## TECHNICAL ADDENDUM

Project No.: R.068431.001

Project title  
**Expansion and Redevelopment of the  
Emerson Port of Entry**  
Emerson, Manitoba

- .1 Refer to Architectural Drawing A6.0-Rev B – Schedules (issued as part of Addendum No. 01 in Amendment No. 002).

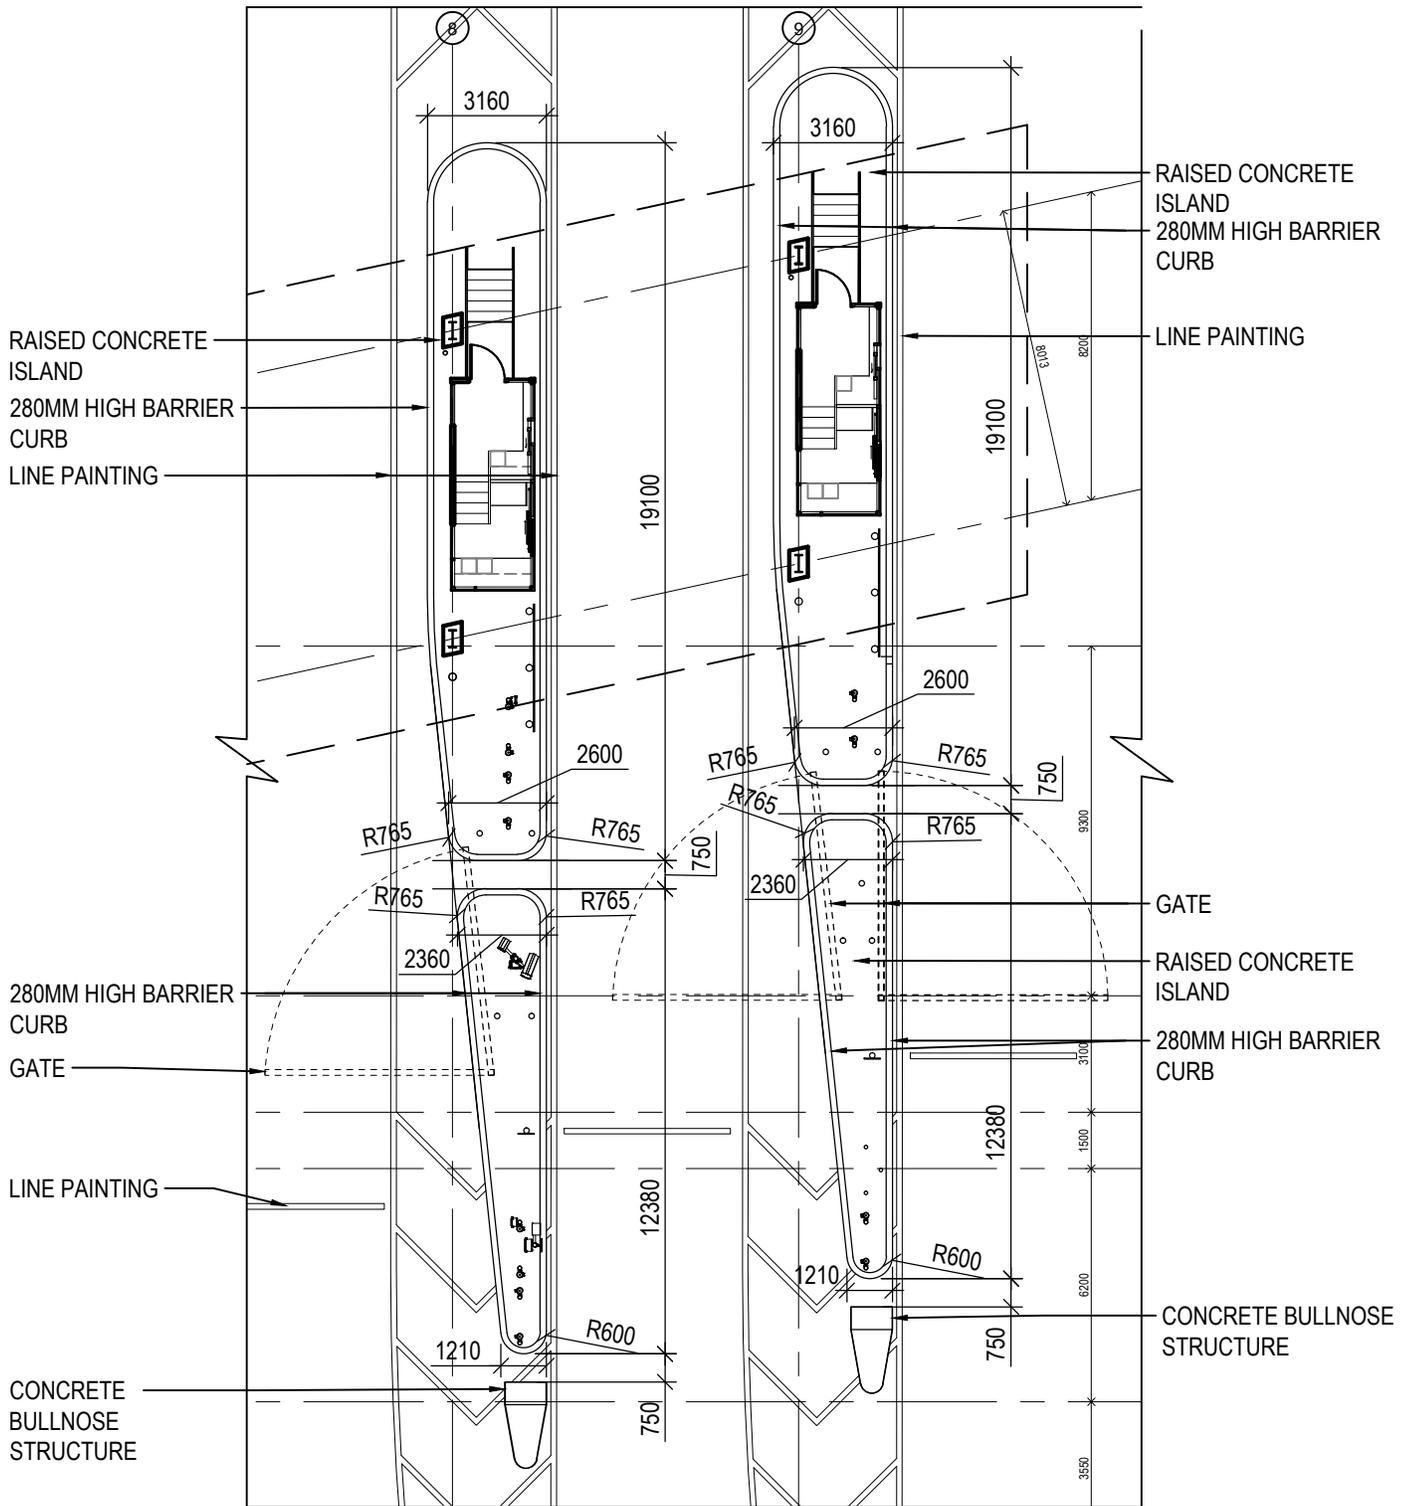
- .1 In Door Schedule: revise doors 406A, 407A, 408A and 409A to read; 406B, 407B, 408B and 409B, and, vice-versa.

Drawing title  
**Site Plan  
Typical PIL Island**

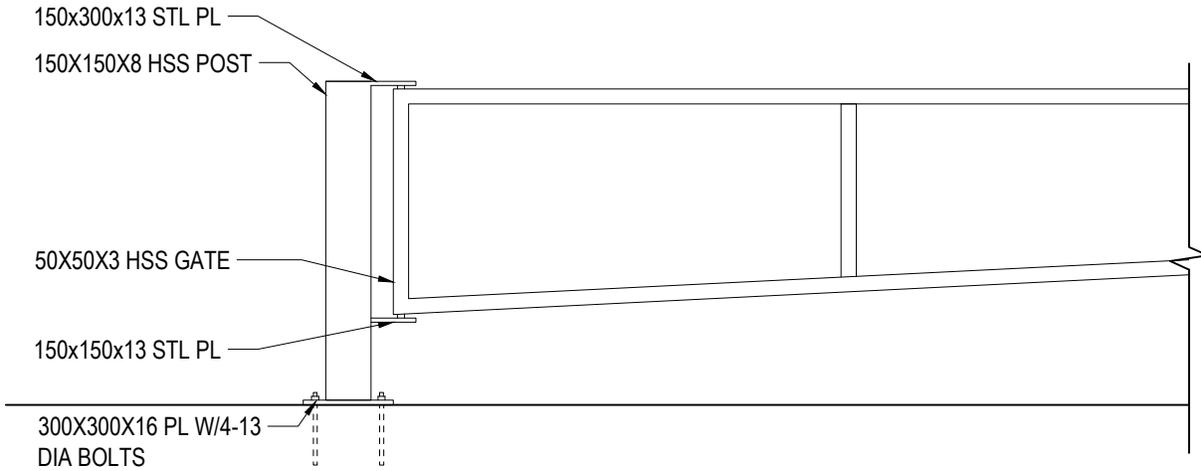
- .2 Refer to Architectural Drawing A1.2 – Floor Plan: New Warehouse Addition, as well as all other related Architectural, Civil, Structural, Mechanical and Electrical Drawings.
  - .1 Revise concrete islands, curbs, bollards, posts, gates, etc.; as indicated on **Architectural Detail Sheet AD5.1 – Site Plan - Typical PIL Island**, and appended to the end of this Addendum.
    - .1 Related work of all other disciplines is to be adjusted accordingly.

Drawing title  
**Sitework  
Gate Details**

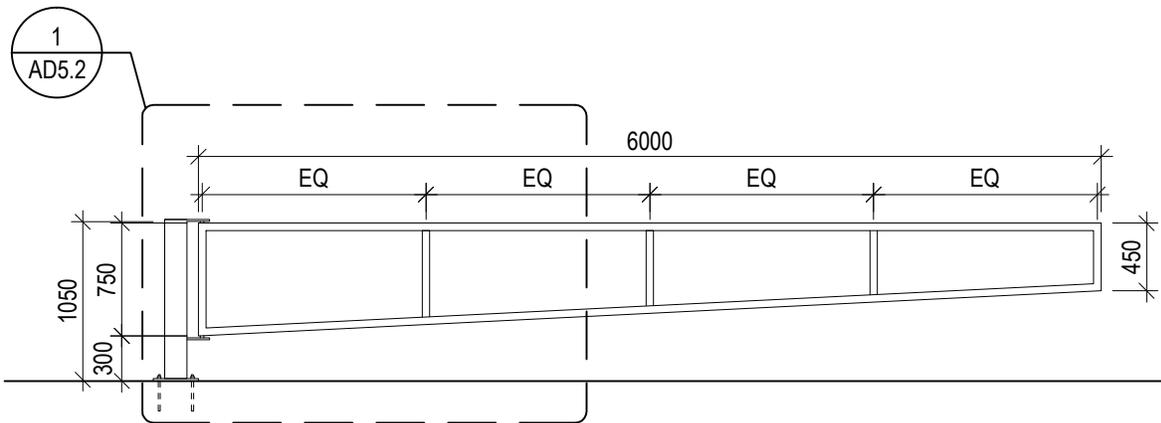
- .3 Refer to Architectural Drawing A1.2 – Floor Plan: New Warehouse Addition, and Architectural Detail Sheet AD5.1 – Site Plan - Typical PIL Island.
  - .1 Revise note on Drawing A1.2 pertaining to “Hinged Metal Gate On Post” from “Refer to Civil” to: “Refer to Architectural Detail Sheet AD5.2 – Sitework Gate Details.
  - .2 **Architectural Detail Sheet AD5.2 – Sitework Gate Details** is appended to the end of this Addendum.
